#3034865-LU
7012 Roosevelt Way NE
Recommendation Phase
05 May 2021
Isola Real Estate VII

7012 Roosevelt Way NE
SDCI# 3034865-LU

City of Seattle Required Early Outreach for Design Review. Summary of Comments Heard at the Community Outreach meeting on February 24, 2020 Per Addendum A of the Outreach Packet.

Proposal - Perspective

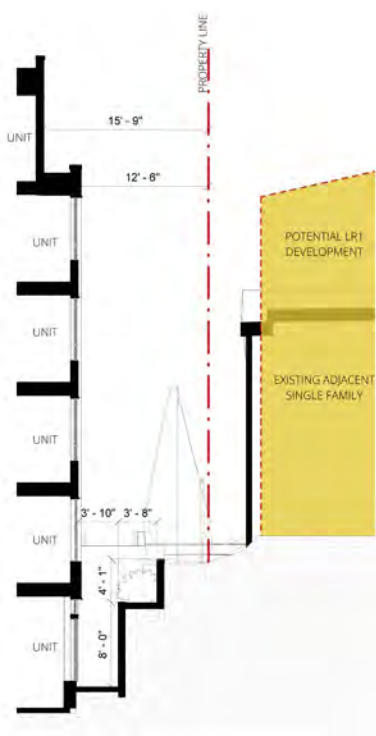
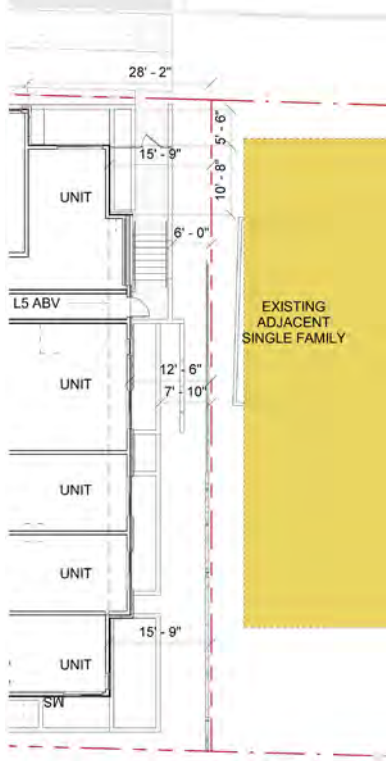
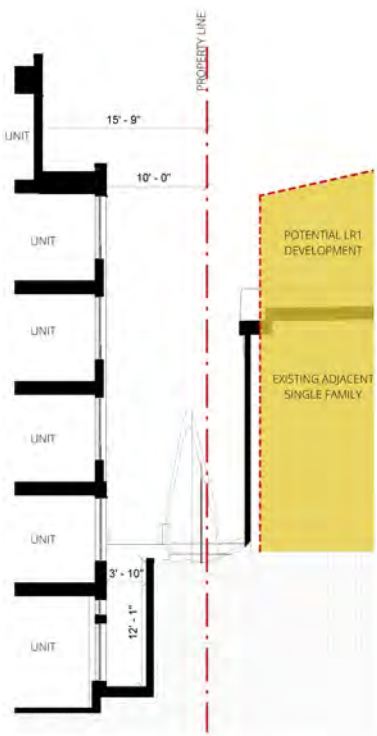
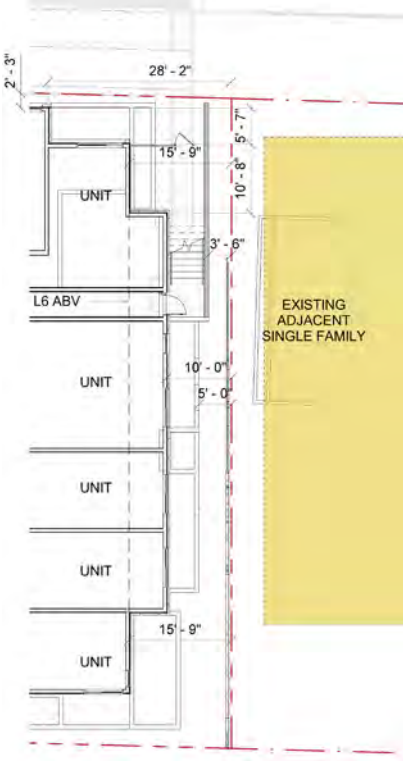
- ① At EDG, staff expressed the preferred massing option began to create a transition in bulk and scale to the neighboring single family but that additional moves would be needed to further accommodate this transition. The design team worked through several iterations (shown here) with the Planner to further develop the transition.
- ②

The massing was approved due to its success at reducing the perceived mass of the gray volume through an increase in height and width of the brick mass and maintaining an increased setback at the east yard (CS2-III-iii, CS2-D-4). See page 12 for additional studies.

The proposed massing provides 12'-6" setback at the lower brick mass and 15'-9" setback at the upper fiber cement mass, creating a stepped massing transition while maintaining a robust planting buffer (6' to 7'-10" wide) between the proposal site and east neighbor. As proposed, the deepest window well can be terraced, allowing more natural light to the unit. The proposed massing strikes a balance between the perceived massing and buffering to the neighbor, responding to Guidelines CS2.D.4 Massing Choices & CS2.III. iii Zone Edges.

The study shows a minimum code required setback for the lower brick massing while maintaining the proposed 15'-9" setback at the upper fiber cement mass. The option creates a more dramatic perceived stepping in the massing but reduces the planting buffer (3'-6" to 5'-0") to the east neighbor. The reduced yard does not allow the window well to be terraced, and reduces the natural light to the unit. This study prioritizes the stepped massing over a robust buffer in contradiction to the Guidelines.

Recommendation Plan

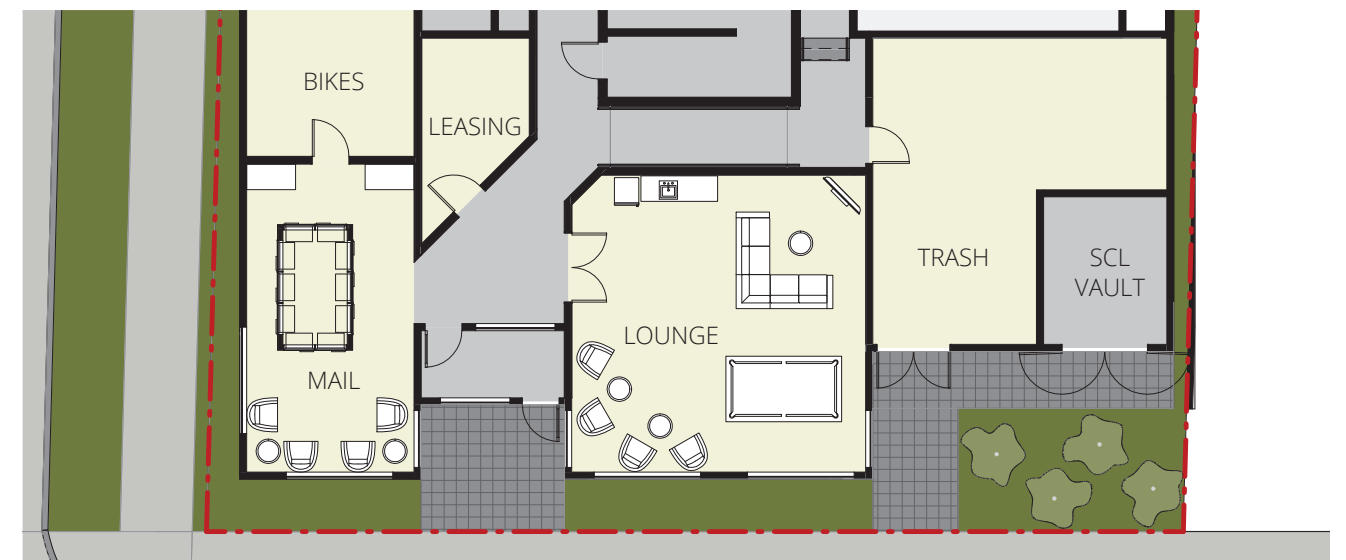
- ③ At EDG, staff expressed concern that the arrangement of spaces along Roosevelt Way NE was unsuccessful in activating the street frontage and recommended exploring how the frontage could be reprogrammed.

- ③ The street level façade and interior programs have been reconfigured to push all high-use programs to the Roosevelt frontage, extension of hardscape onto property allows for more engagement. By shifting the residential entry south, the lounge was located at the prominent corner, allowing more visual interaction from the street and occupants. The mail area is kept open on the frontage, creating a transition in rhythm to the secured service area. The service area has been screened with a semi-transparent fence/gate as well as freestanding, elevated planters (CS2-B-2, CS2-C-I).

Partial Plan - East Yard

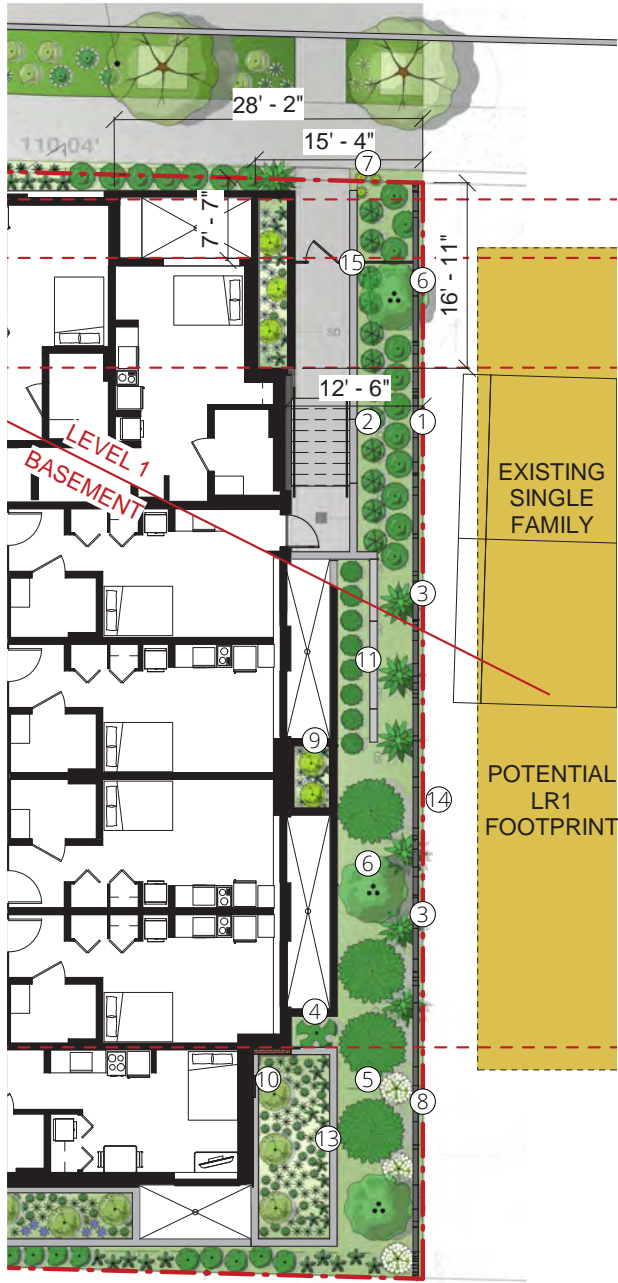
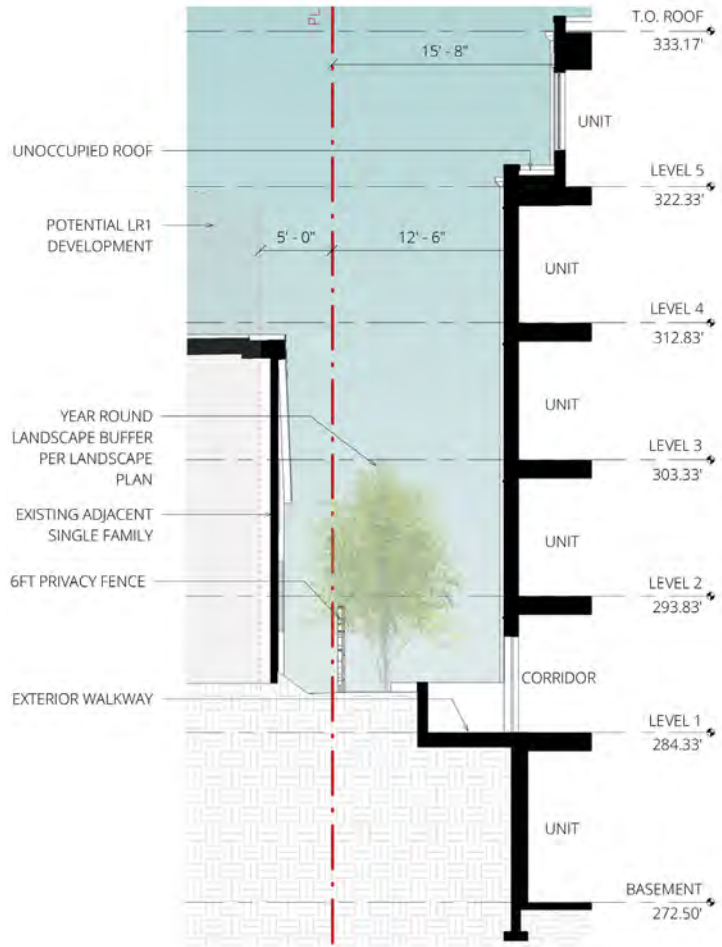
② At EDG, staff requested studies and treatment of the east yard to minimize privacy impacts with the adjacent single family home to the east . The window overlap diagram shown here indicates the neighboring home's windows will overlap with just one other unit. This overlap will be further reduced with the addition of both a 6ft privacy fence and year-round plantings designed as an additional privacy buffer (CS2-III).

On the east side of the property specific plant material has been chosen to provide a year-round buffer to the neighboring property. The Pacific Wax Myrtle in particular, is an excellent screening plant, which can reach a height of 30 feet and also responds well to pruning if needed. The majority of the plants are evergreen with the exception of the Vine Maple and White Icicle Flowering Currant. The Vine Maple was chosen to provide some additional height without being a maintenance issue in the future. The design provides a tiered screen with lower evergreen plants in the front and taller evergreens in the back, which will further buffer the property as well as provide visual interest year-round.

Aerial View - East Yard (Looking north)

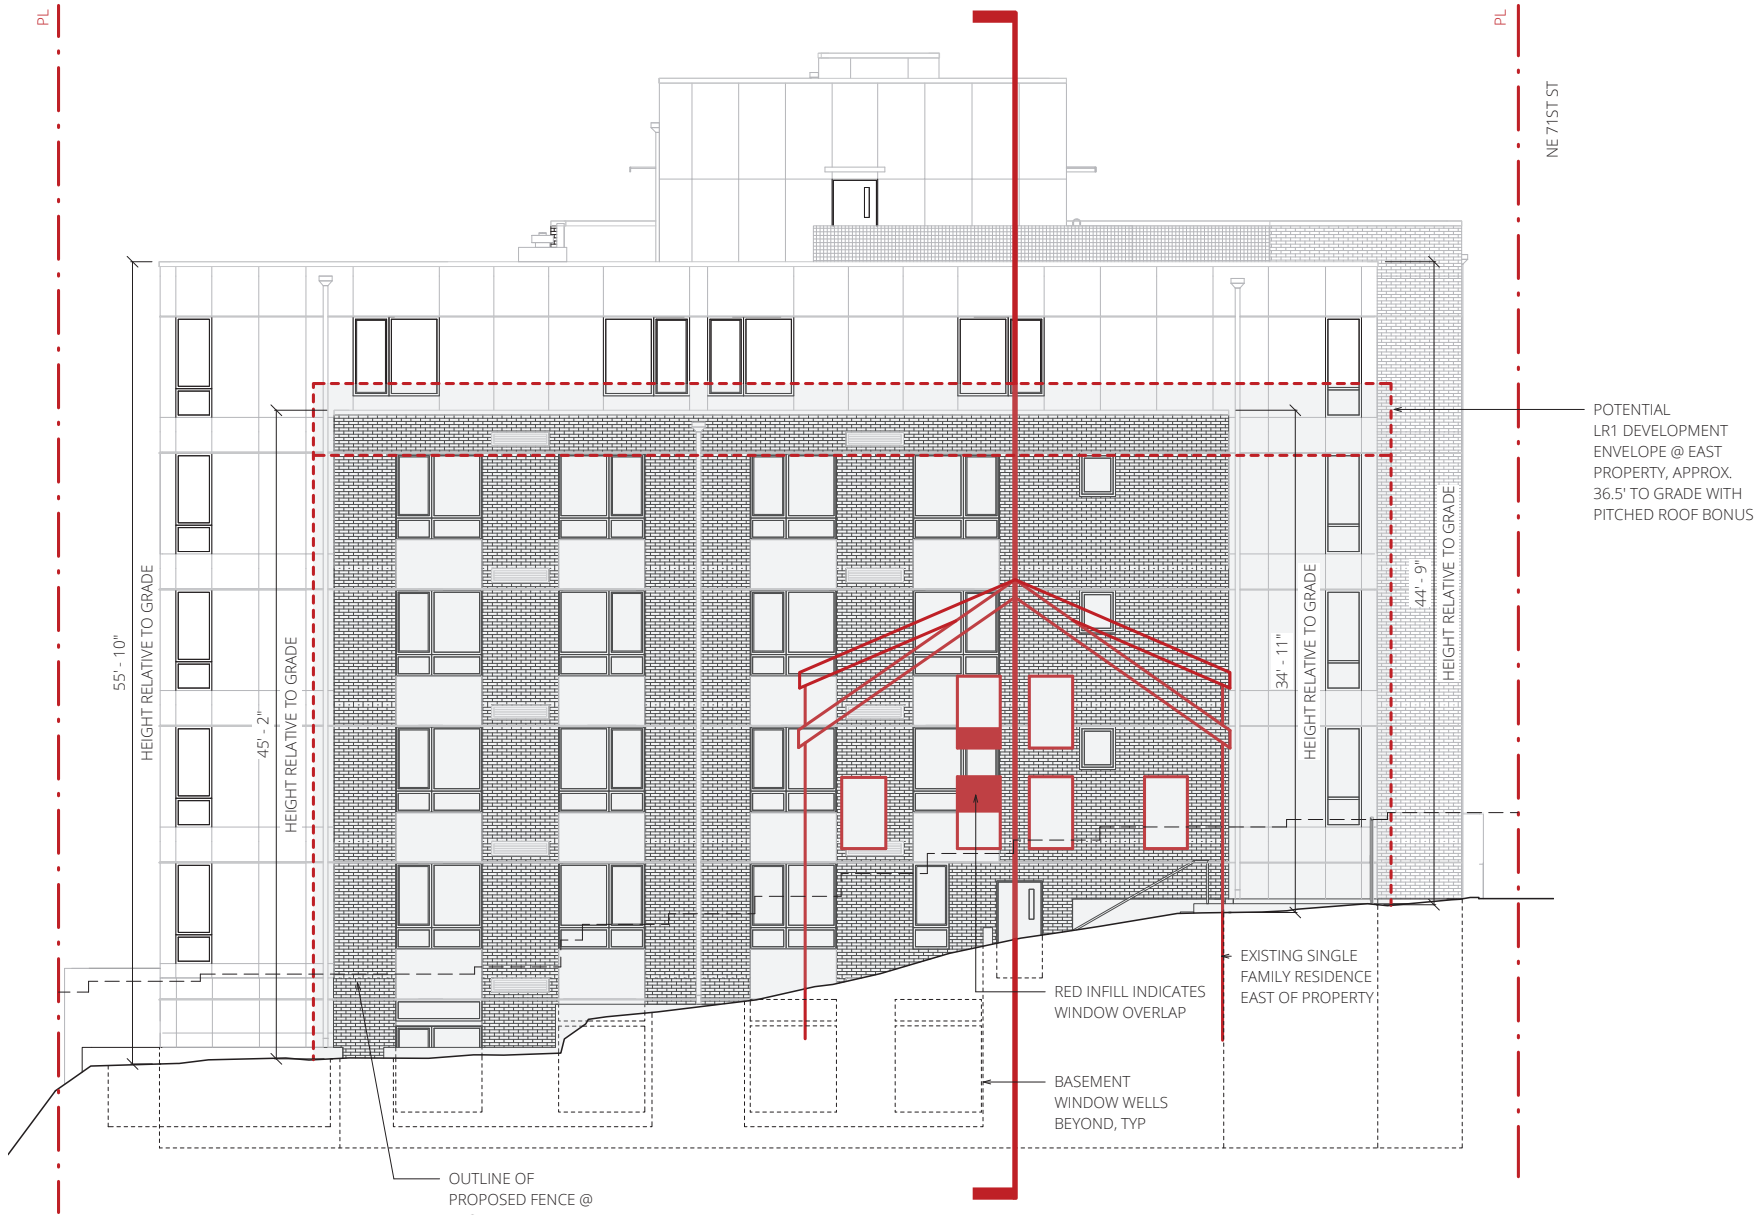
② At EDG, staff expressed that while the massing at the east was beginning to respond to the low rise zone to the east, the perceived bulk needed to be further studied. After additional design studies, the approved solution was to raise the brick volume one level, thereby modifying the proportion of the transition. By increasing the height of the smaller volume, the dark massing appears to recede and the perceived transition is more gradual to the east (DC2-D-2). Plantings have been carefully chosen to provide a year-round lush, dense landscape buffer, providing privacy and an additional transition in scale (CS2-III, CS2-D).
